ADDENDUM NO. 2

**DOCTORS HEALTHCARE AND
REHABILITATION CENTER**

BYSP PROJECT NO. 10106

DEDUCT. ALT. 2 15 HAND RAIL/CRASH RAIL

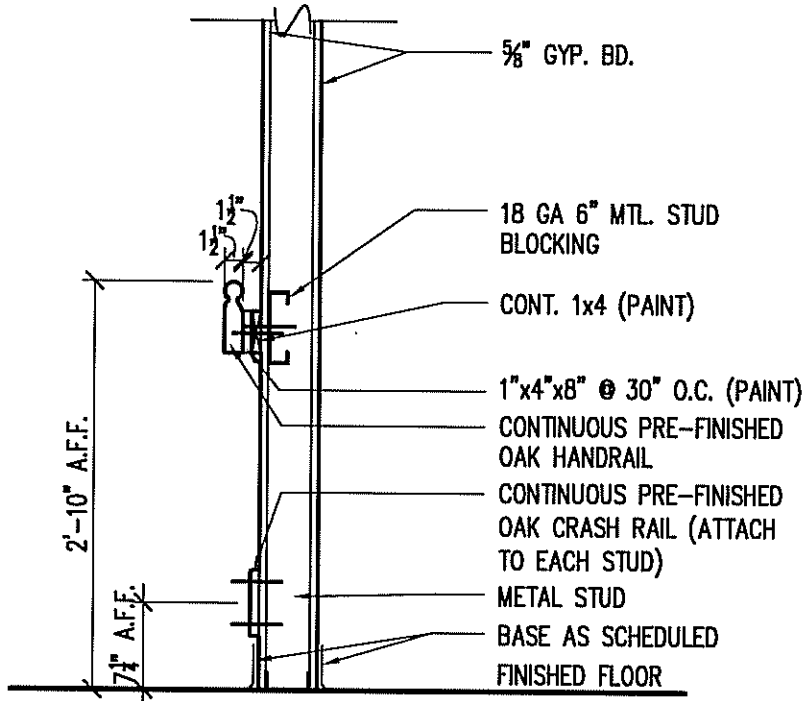
Sheet A406: Add Crash Rail detail to 15/A406 as shown on attached sheet A406.3. Crash rail to be part of Deductive Alternate 2.

NOTE: HANDRAILS SHALL SUPPORT A VERTICAL LOAD OF 250 LBS. ENDS SHALL BE MITERED AND RETURNED TO WALL AT ALL LOCATIONS

<p>⊕ BASE BID HANDRAIL HRL-1 AND CRASH RAIL CR-1 AS SHOWN IN THE MATERIALS LEGEND (INTERIORS)</p>
--
